Type: **Announcement**
 Title: **Lamps with Yellow Reflector on V43-V47**

WB-27
 April 28, 2017
 Page 1 of 1

3rd Party Lamps are causing False Color Wheel Errors

Lamp w/Yellow Reflector

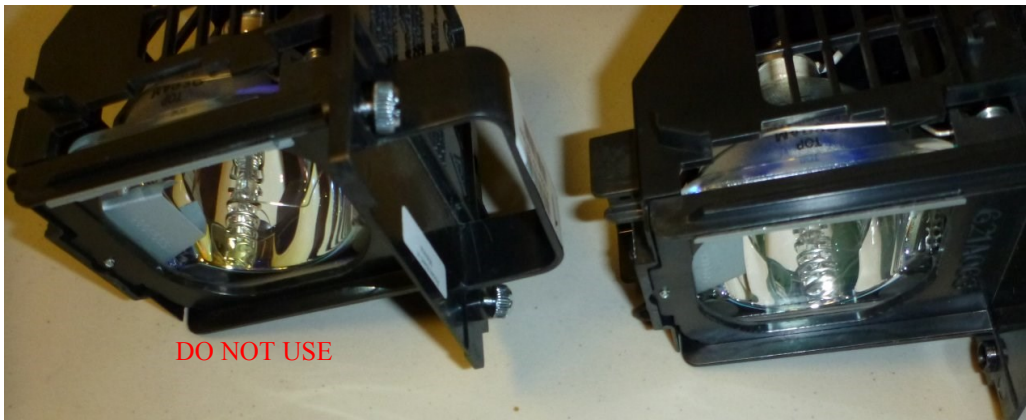
Mitsubishi is aware of 3rd party lamps that are assembled with a yellow tint reflector that causes interference with the color wheel sensor and mimics a fault with the color wheel.

Symptoms of lamps with a yellow reflector are:

- Flickering/flashing picture
- Error Code 16
- Buzzing/screeching sound from color wheel/lamp area
- Inability to adjust Index Delay
- Colors wrong or blotchy colors

Do Not use Lamps with Yellow Reflector on These Models

Subsequently, Color Wheel part number **(938P215010) is on T/A Required.** Please call 800-888-6773 to obtain authorization for the color wheel. A genuine Mitsubishi lamp must have been installed in the TV prior to approval. Lamps can be purchased at <https://mitsuparts.3diamonds.com> or by calling 800-553-7278.

Lamp w/Silver Reflector (correct)
